ANN ARBOR HISTORIC DISTRICT COMMISSION

Staff Report

ADDRESS: 117 N Division Street, Application Number HDC24-0171

APPLICATION: The applicant seeks HDC approval to install a wood fire escape on the north (side) elevation of the building.

James Dudzinski ARCHITECT 12306 Volpe Sterling Heights, Mi. PH. (586) 864-6930	PROJECT TITLE: NEW STAIR	PROJECT LOCATION: 117 N DIVISION ANN ARBOR, MI	SHEET TITLE: PLAN ELEVATIONS	MARK:	DATE:	ISSUED FOR:	MARK:	DATE:	ISSUED FOR:	SHEET SIZE 18X24	SHEET NO: 1 OF 2 A1
					11/18/22	DRAWN

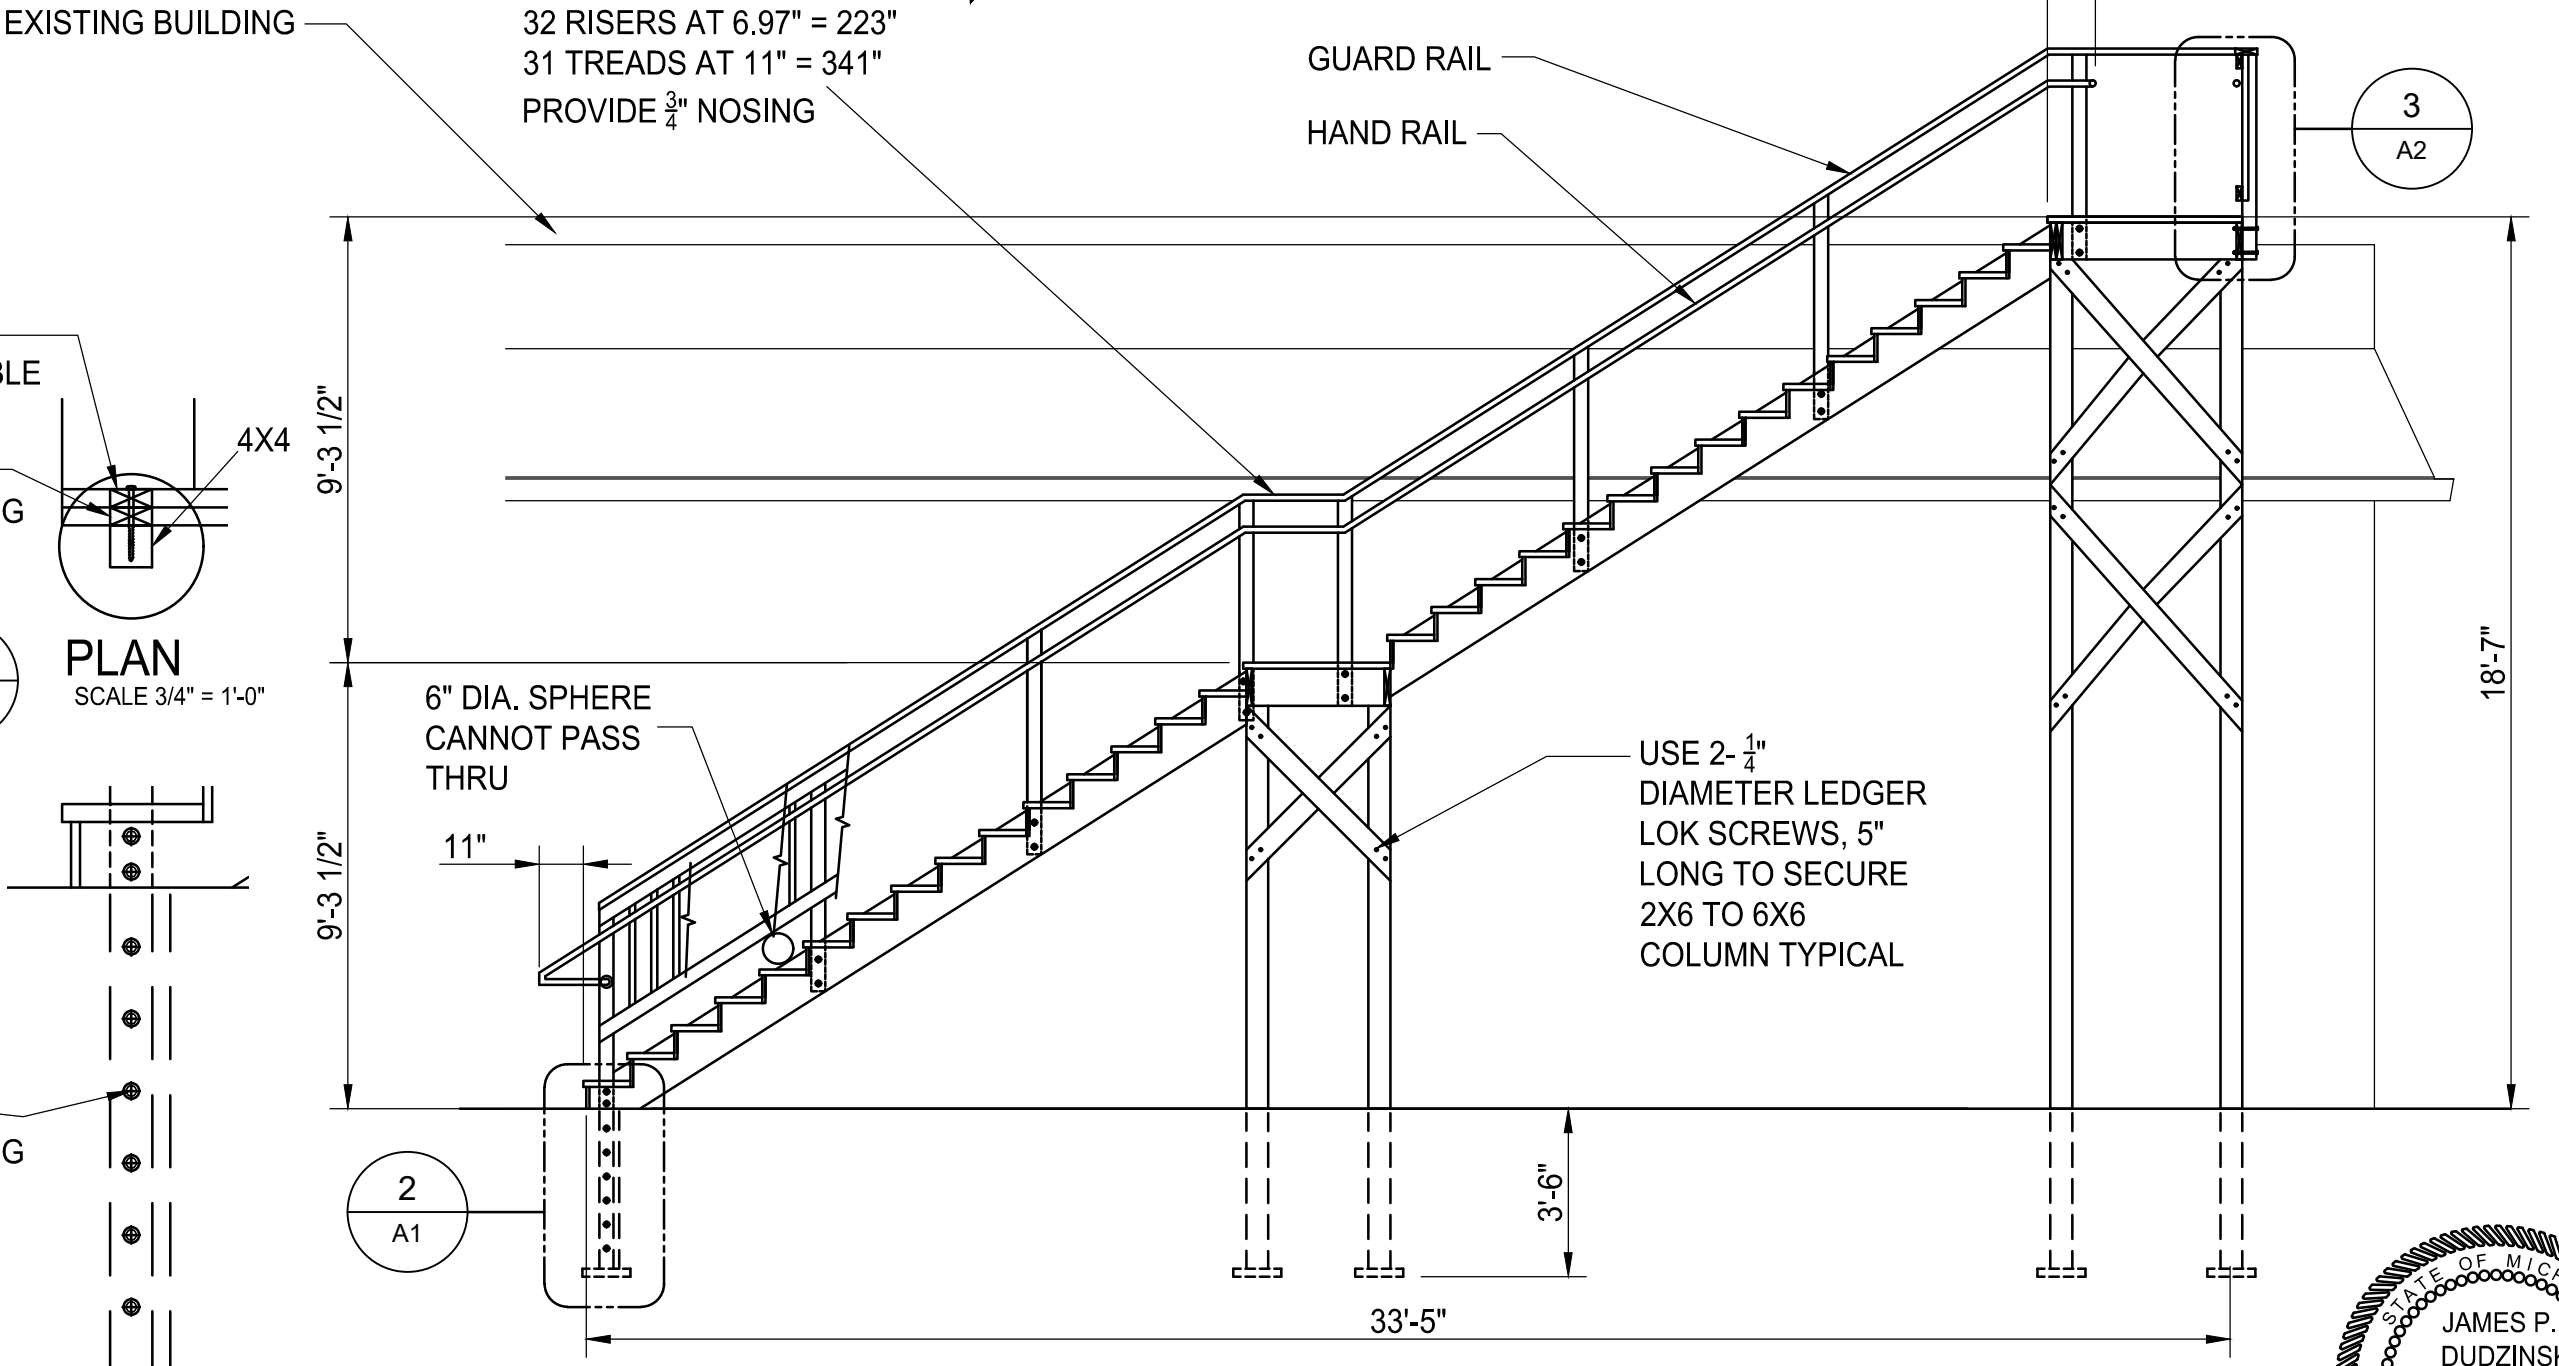
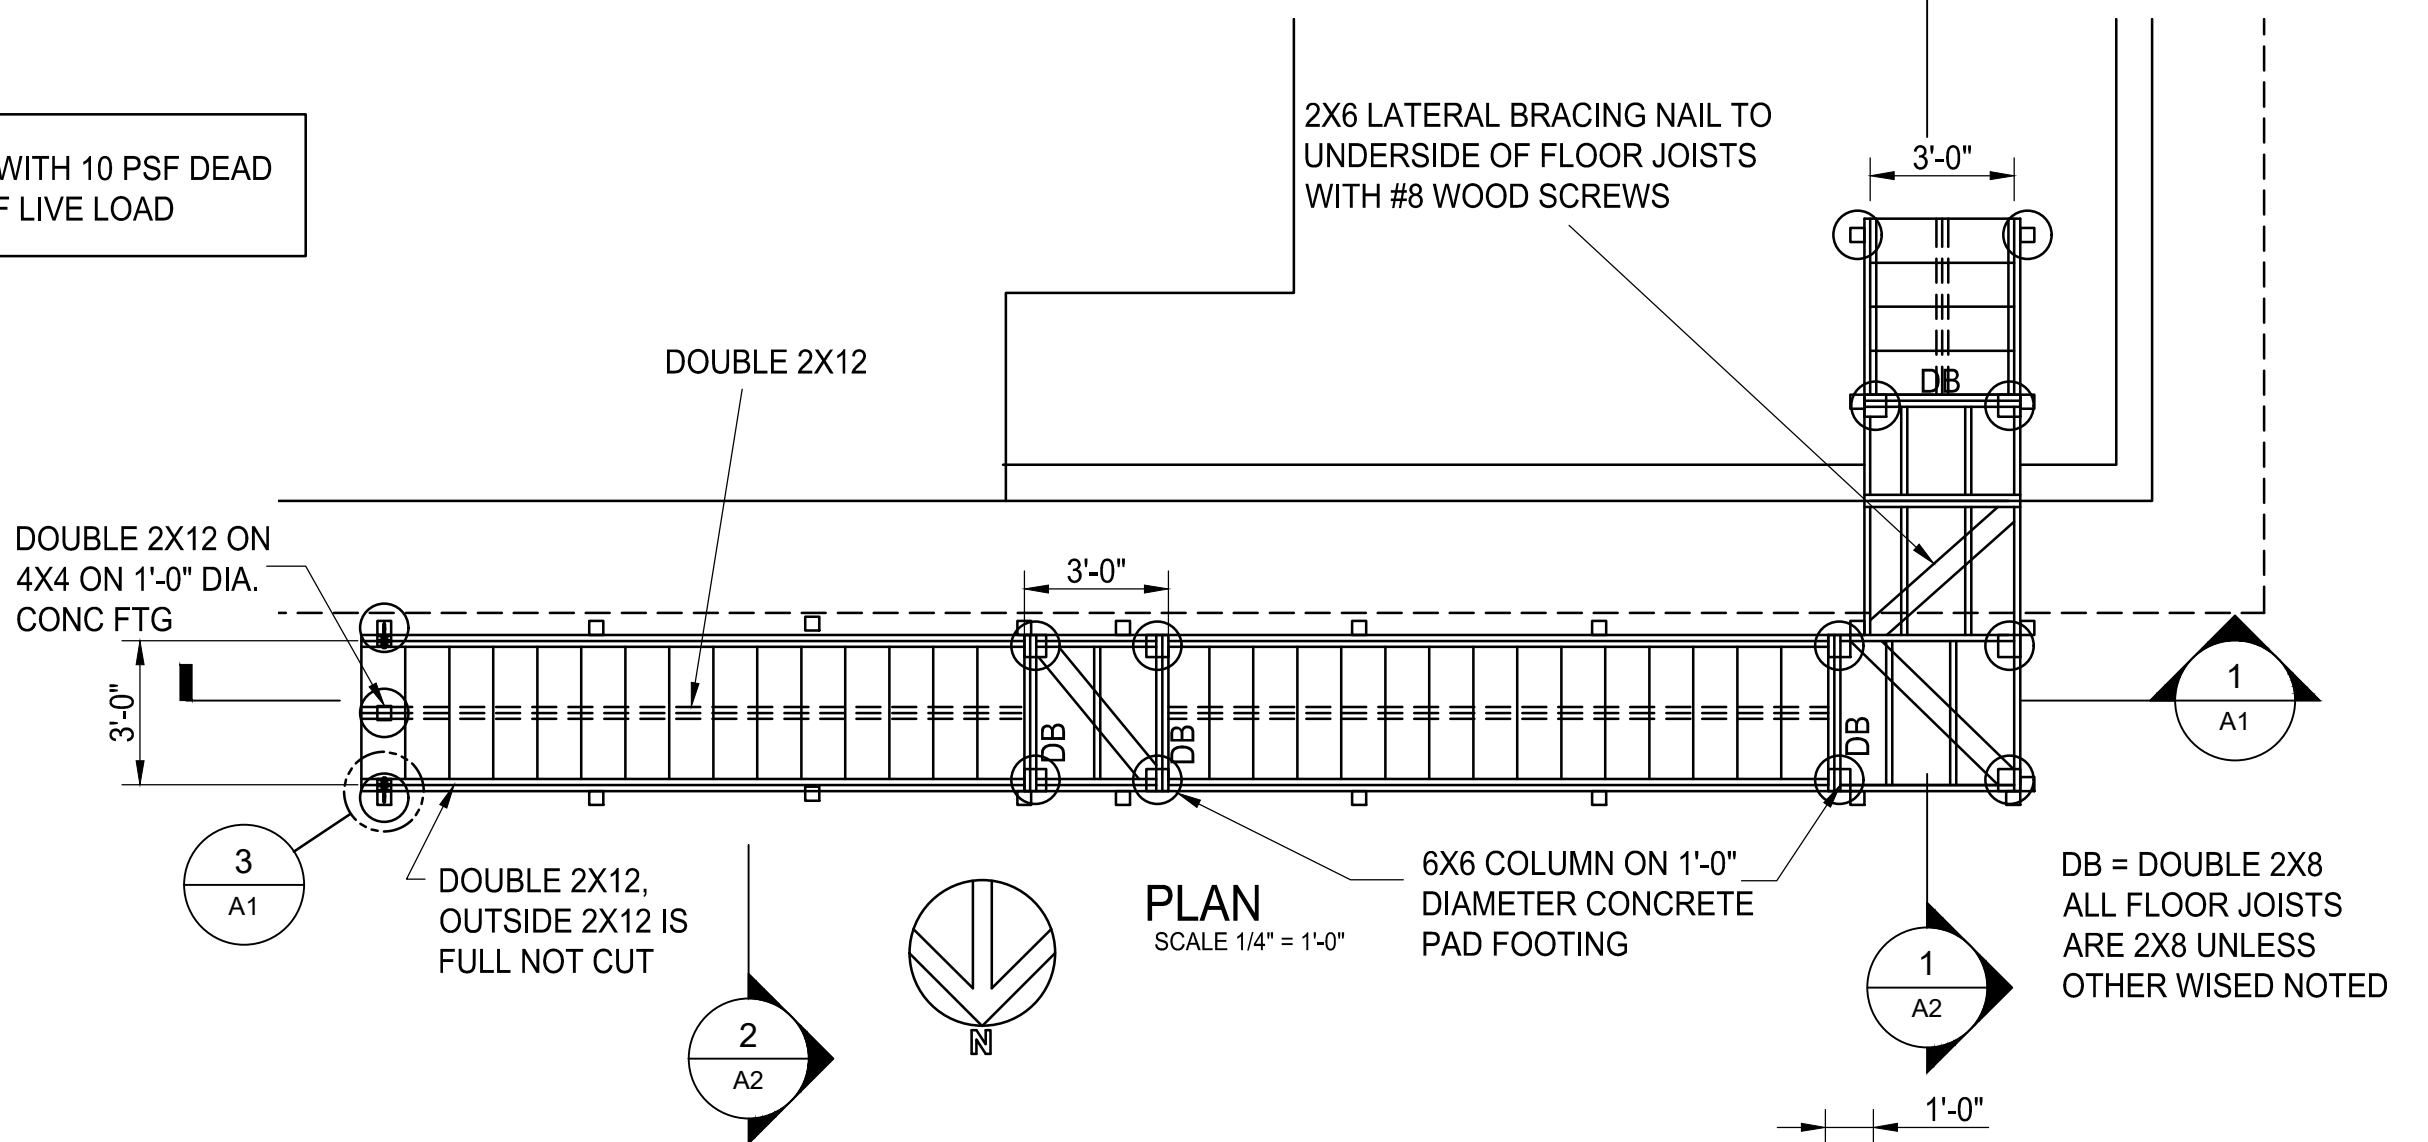
1. The applicant is proposing a new fire escape stair on the north (side) elevation of the building. It will be attached to the roof of the west (rear) bump out and then run along the north side of the building towards Division Street. According to the applicant, the fire escape is required by code. The structure, stairs, and guardrail will be treated wood. The design is utilitarian and features closed risers and a side-mounted graspable handrail. The balusters are applied to the outsides of an upper and lower rail. Since this is not part of a historic feature of the house like a front porch, that could be found acceptable.

2. An earlier fire escape stair was located at the rear of the house, also attached to the roof of the bump out but then ran along the west (rear) elevation. It was recently removed (date uncertain) when the parking lot at the rear of the house was leveled. The former fire escape was wood. Per the applicant, the proposed location on the north side of the building allows for more efficient use of the parking lot.

3. No historic materials or features would be impacted, compromised, or destroyed by the fire escape stair. Its impacts would be mainly visual. The work is reversible.

4. While typically fire escape stairs are being removed from structures in historic districts, if this one is required by code, it is generally compatible in exterior design, arrangement, material and relationship to the rest of the site and the surrounding area.

I move that the Commission issue a certificate of appropriateness for the application at 117 N Division Street, a contributing property in the Old Fourth Ward Historic District, to remove the existing exterior fire escape stair on the rear of the building and construct a new exterior fire escape stair on the north side of the building. As proposed, the work is compatible in exterior design, arrangement, material, and relationship to the building and the surrounding area and meets *The Secretary of the Interior's Standards for Rehabilitation* and *Guidelines for Rehabilitating Historic Buildings*, in particular standards 1, 9, and 10 and the guidelines for health and safety and additions, as well as the *Ann Arbor Historic District Design Guidelines* for additions and safety codes.
